CONTINENTAL MOTORS® AIRCRAFT ENGINE
CRITICAL SERVICE BULLETIN

CATEGORY 2
CSB15-2A

SUBJECT: Oil Cooler Cross Fitting Replacement

PURPOSE: To replace oil cooler cross fitting (part numbers AN918-1J and AN918-2J) with a new enhanced cross fitting (P/N 658607).

Figure 1. Cross Fitting Stack-Up, Prior Configurations

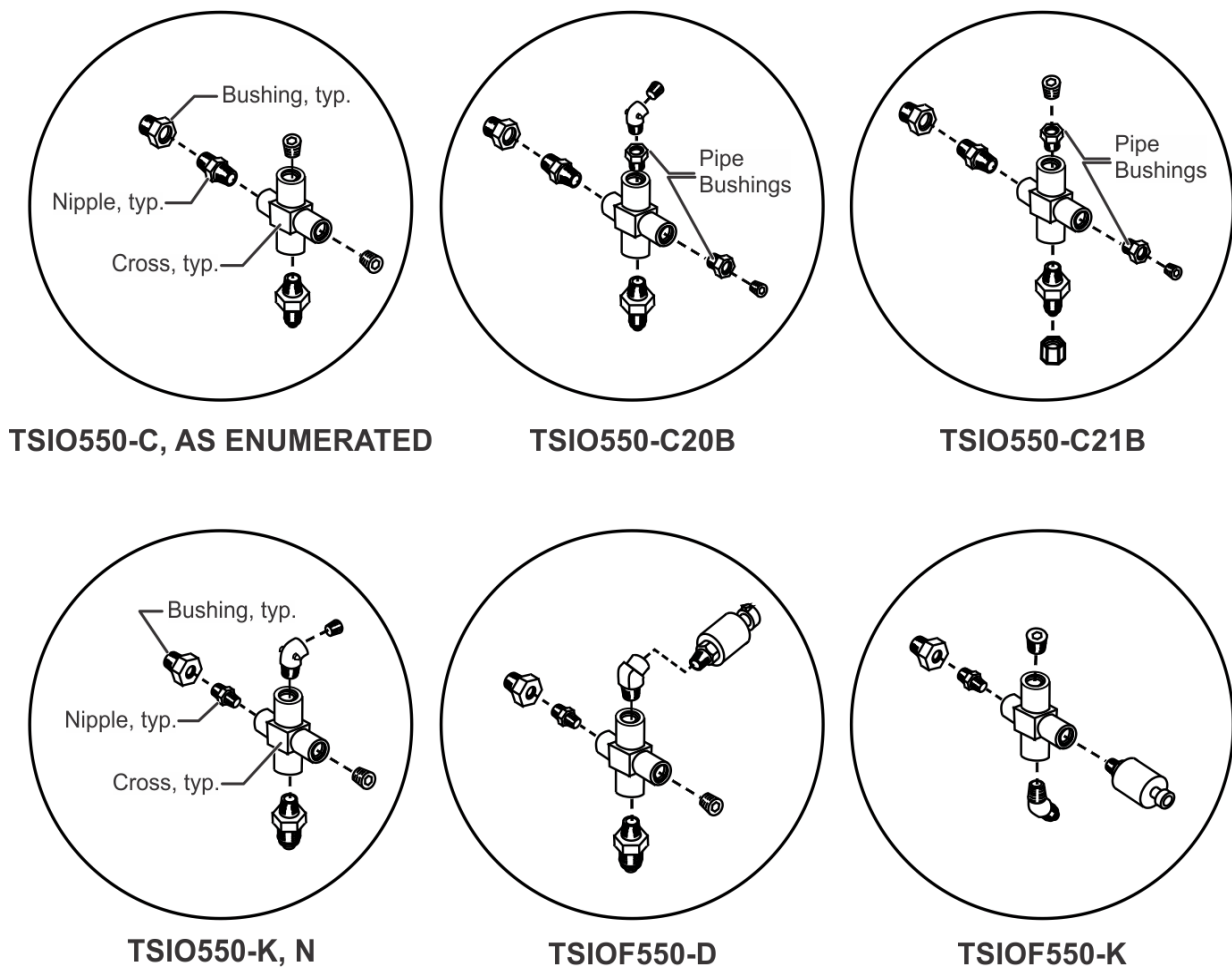
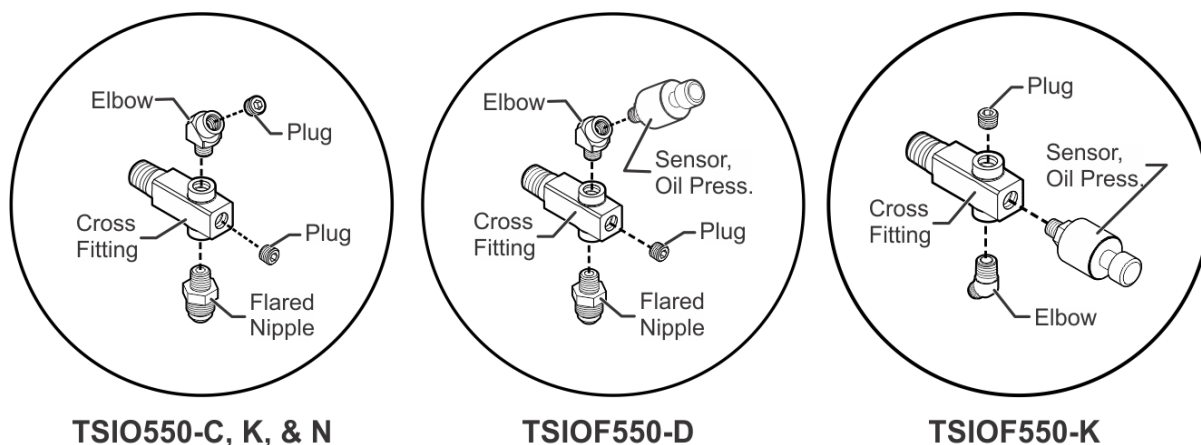
Continental Motors, Inc. (CMI) is aware of some occurrences in which there was a loss of engine oil due to a fractured nipple fitting that connects the cross fitting to the pipe bushing at the oil cooler. Design improvements consolidate the oil cooler cross fitting stack-up into a single part, which significantly increases the strength and provides a simplified installation procedure for installing the oil cooler cross fitting found on specified TSIO-550 and TSIOF-550 engines.

1. Eliminate the pipe bushing and nipple fitting stack-up (see Figure 1) typically found between the cross fitting and the oil cooler and replaces them with a single cross fitting (P/N 658607).

4. Remove the additional pipe bushings (P/N AS4861J01) used for the oil pressure sensor and pipe plug previously installed on TSIO550-C20B and -C21B installations (see Figure 1). These bushings are obsolete (for this application) and will no longer be necessary for the new cross fitting installation; the AN915-1J 45-degree elbow fitting or pipe plugs fit directly into the new cross fitting (see Figure 2).

REMOVE AND REPLACE the superseded parts with new cross fitting (P/N 658607) using the same procedures located in your M-18 or M-26 Maintenance and Overhaul Manuals. Reference the latest revision of the CMI Illustrated Parts Catalog (IPC) to determine applicable additional connectors, elbows, or plug part numbers and adjust the instructions accordingly.

Figure 4. Hose and Tube Installation Support

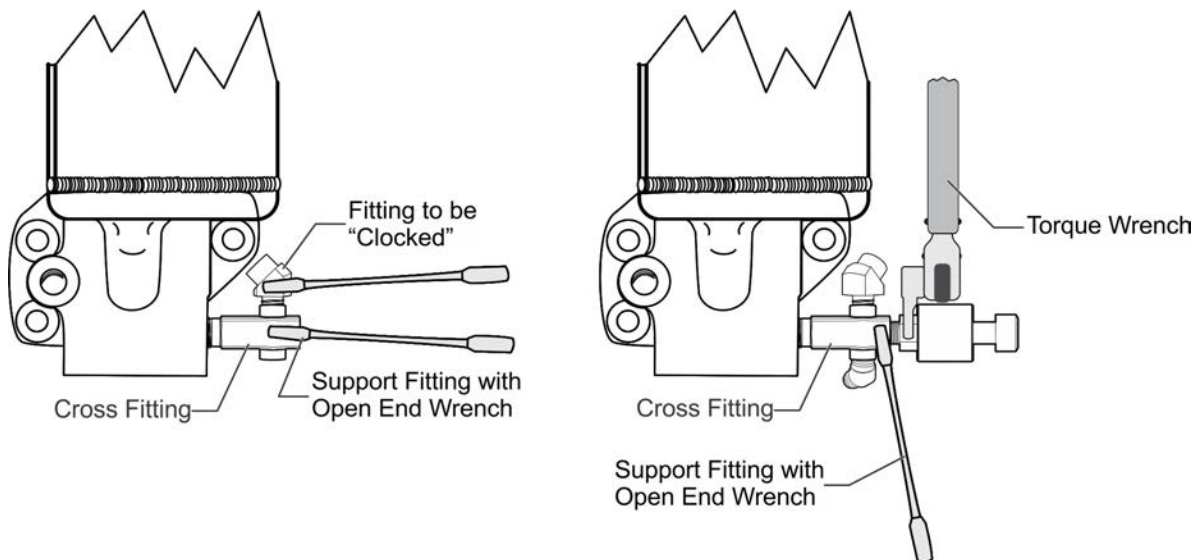
- b. Support the last fitting in the assembly on components that contain multiple fittings coupled in one location (see Figure 4). DO NOT over-torque fittings.

Figure 1. Cross Fitting Stack-Up, Prior Configurations

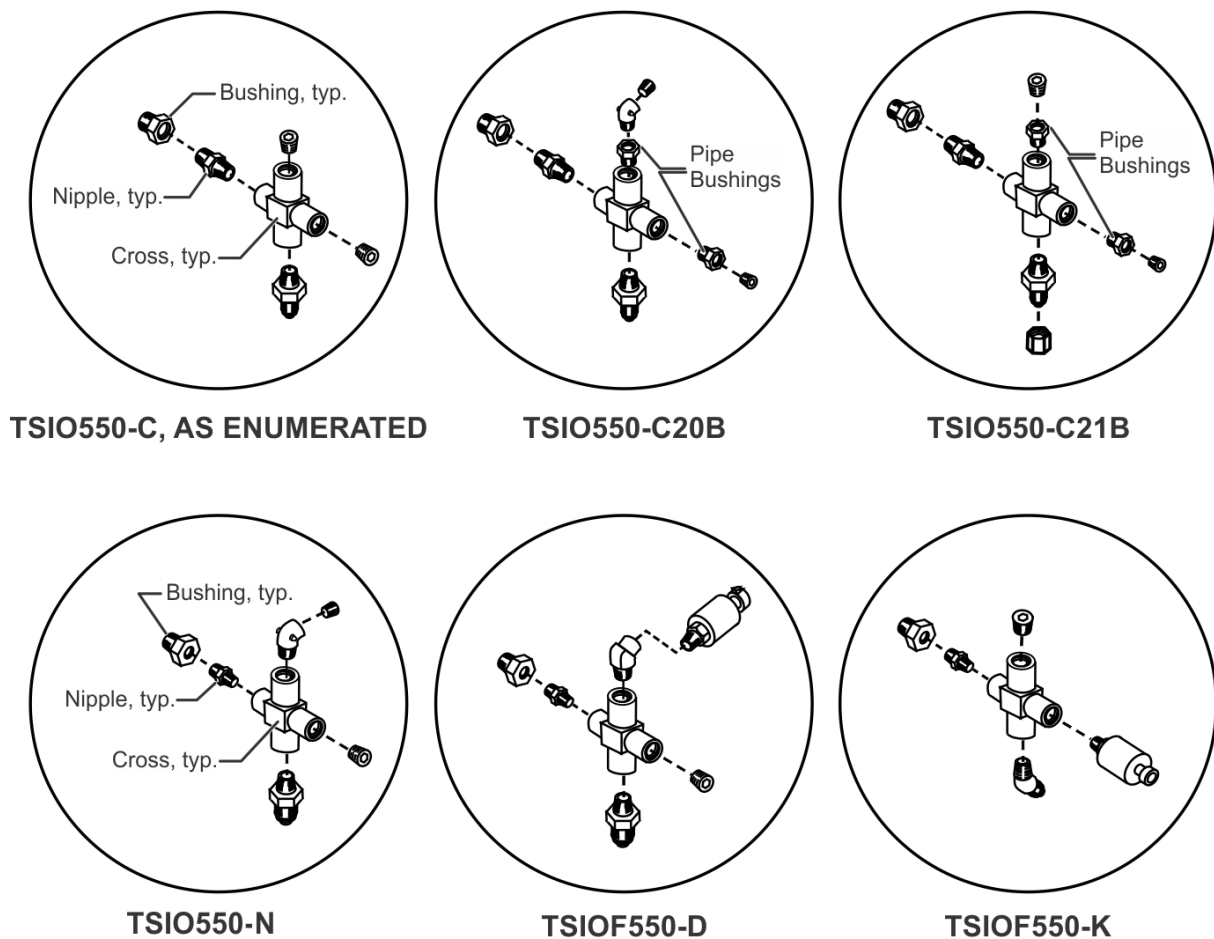
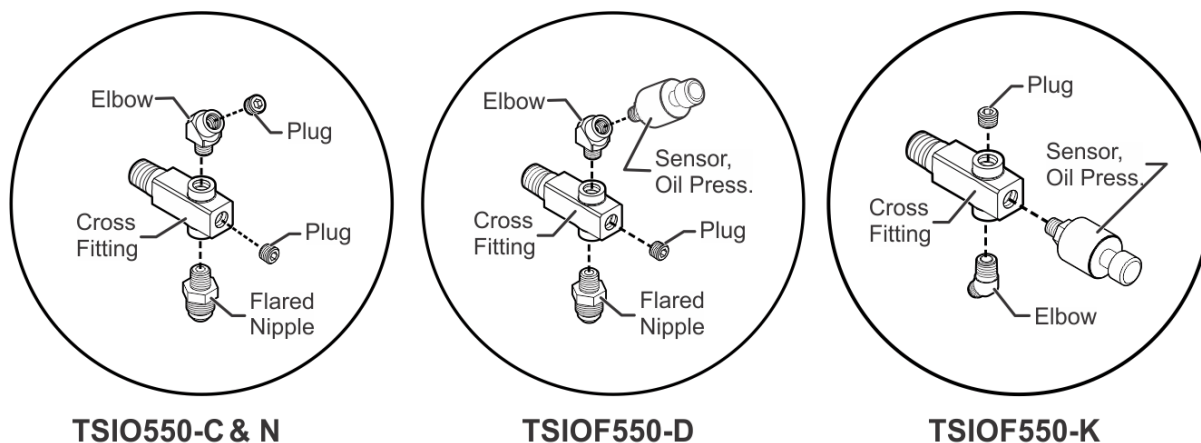
1. Eliminate the pipe bushing and nipple fitting stack-up (see Figure 1) typically found between the cross fitting and the oil cooler and replaces them with a single cross fitting (P/N 658607).

4. Remove the additional pipe bushings (P/N AS4861J01) used for the oil pressure sensor and pipe plug previously installed on TSIO550-C20B and -C21B installations (see Figure 1). These bushings are obsolete (for this application) and will no longer be necessary for the new cross fitting installation; the AN915-1J 45-degree elbow fitting or pipe plugs fit directly into the new cross fitting (see Figure 2).

REMOVE AND REPLACE the superseded parts with new cross fitting (P/N 658607) using the same procedures located in your M-18 or M-26 Maintenance and Overhaul Manuals. Reference the latest revision of the CMI Illustrated Parts Catalog (IPC) to determine applicable additional connectors, elbows, or plug part numbers and adjust the instructions accordingly.

Figure 4. Hose and Tube Installation Support

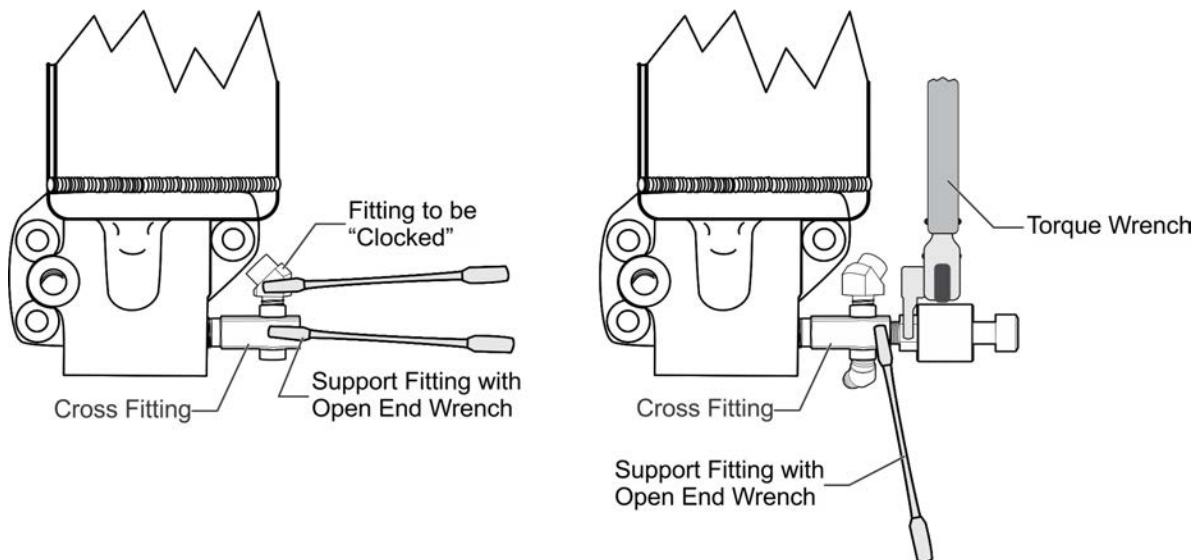
- b. Support the last fitting in the assembly on components that contain multiple fittings coupled in one location (see Figure 4). DO NOT over-torque fittings.

Figure 1. Cross Fitting Stack-Up, Prior Configurations

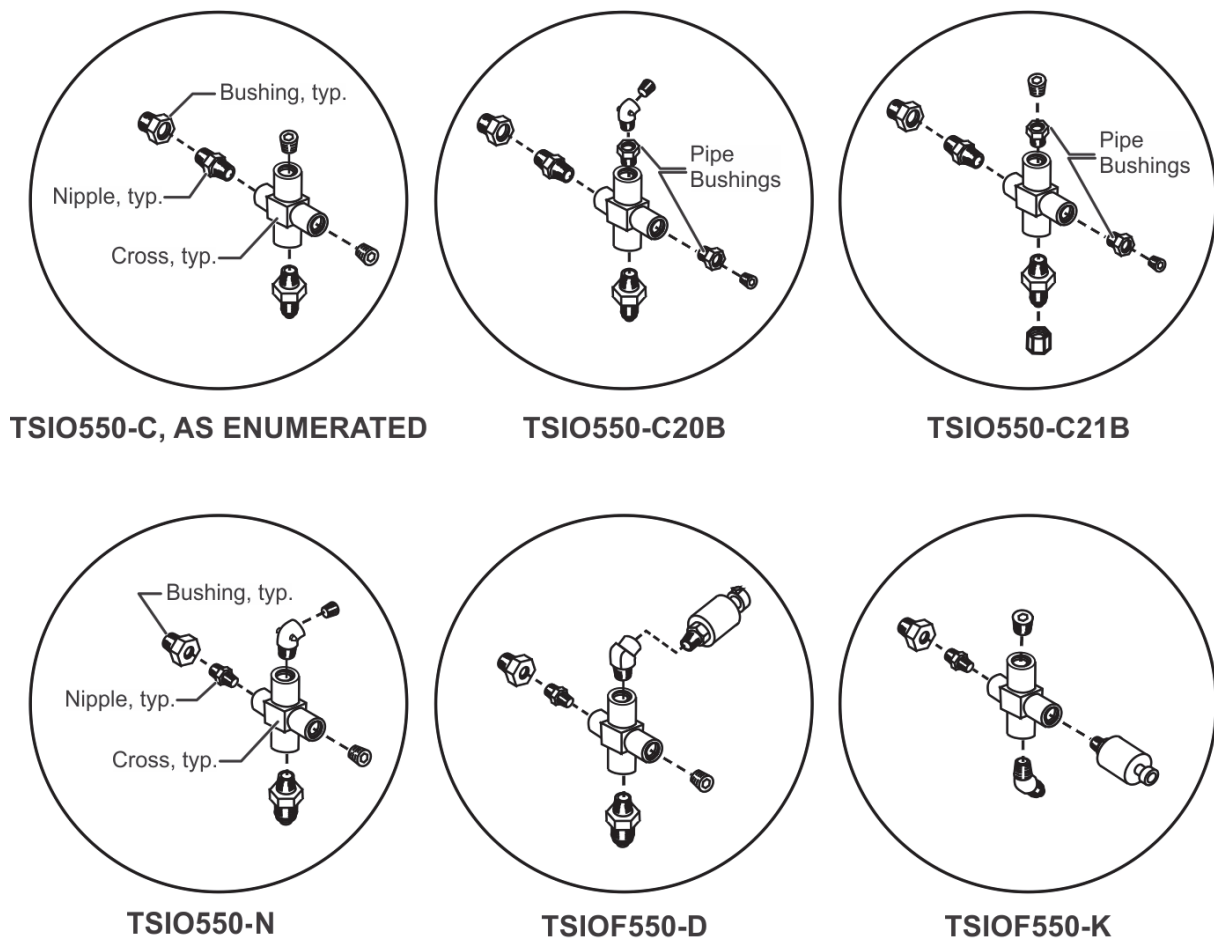
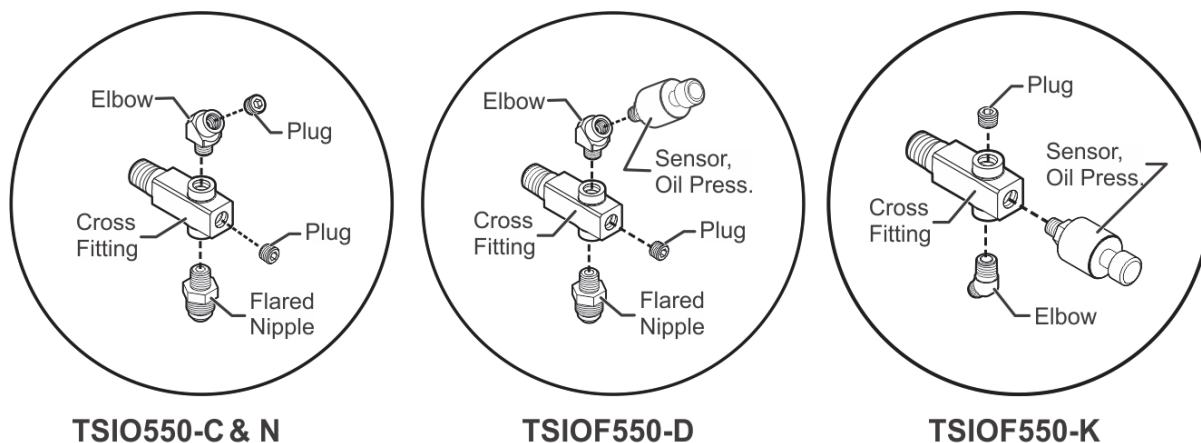
1. Eliminate the pipe bushing and nipple fitting stack-up (see Figure 1) typically found between the cross fitting and the oil cooler and replaces them with a single cross fitting (P/N 658607).

4. Remove the additional pipe bushings (P/N AS4861J01) used for the oil pressure sensor and pipe plug previously installed on TSIO550-C20B and -C21B installations (see Figure 1). These bushings are obsolete (for this application) and will no longer be necessary for the new cross fitting installation; the AN915-1J 45-degree elbow fitting or pipe plugs fit directly into the new cross fitting (see Figure 2).

REMOVE AND REPLACE the superseded parts with new cross fitting (P/N 658607) using the same procedures located in your M-18 or M-26 Maintenance and Overhaul Manuals. Reference the latest revision of the CMI Illustrated Parts Catalog (IPC) to determine applicable additional connectors, elbows, or plug part numbers and adjust the instructions accordingly.

Figure 4. Hose and Tube Installation Support

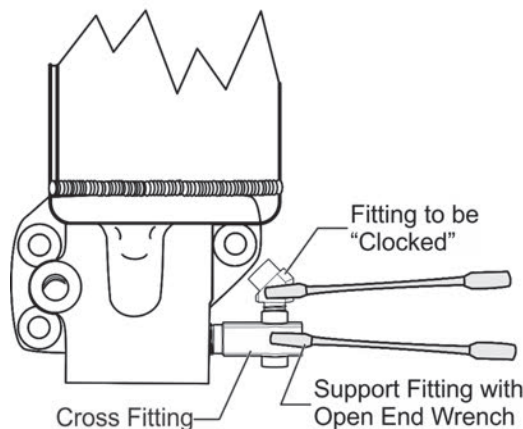
- b. Support the last fitting in the assembly on components that contain multiple fittings coupled in one location (see Figure 4). DO NOT over-torque fittings.
